*Design Review Board
May 4, 2016*

MINUTES OF A REGULAR MEETING OF THE DESIGN REVIEW BOARD OF THE TOWN OF CLARKDALE HELD ON WEDNESDAY, MAY 4, 2016, AT 6:30 P.M. IN THE MEN'S LOUNGE OF THE CLARK MEMORIAL CLUBHOUSE, 19 N. NINTH STREET, CLARKDALE, AZ.

- a. **CONSIDERATION AND POSSIBLE ACTION DRB #091228:** Discussion/possible action regarding an application for design review of a proposed monument sign for a new business, Sedona Wellness, located at 414 Peace Garden Path, parcel number 400-07-026F.

- a. **CONSIDERTION AND POSSIBLE ACTION DRB #091242:** Discussion/possible action regarding an application for design review of a proposed wall sign and off-premise sign, located at Olsen's Grain, 1171 State Route 89A, Parcel # 406-26-314D.

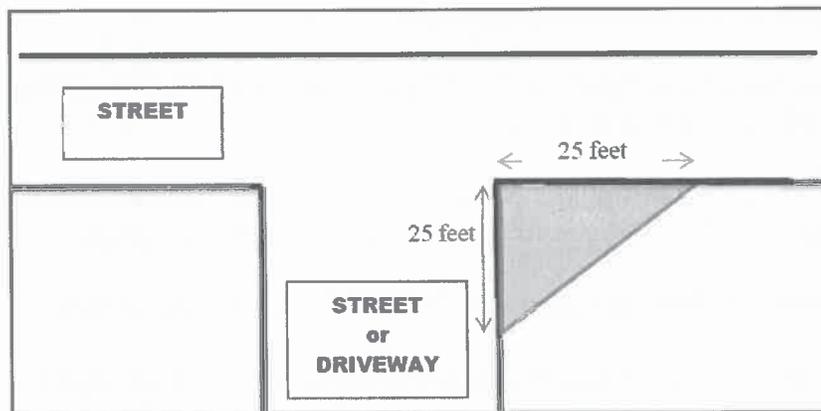
3. ***Maximum projection from wall surface equals 18 inches, with a minimum clearance of 9 vertical feet if located over a public right-of-way.*** The sign does not project from wall. Application complies.
4. ***See section 7-9 of this Code for maximum sign square footage.*** The 39 square feet of additional signage is proposed for this existing business. Minus the existing signage there is a remainder of 214.19 square feet of signage available for this property.

Calculation of remaining allowed signage space:

177 total considered linear feet x 1.5 square feet allowed per linear foot = 265.5 total permitted signage in square feet

214.19 square feet of signage available – 39 square feet of requested signage per this application = 175.19 square feet remaining for additional signage
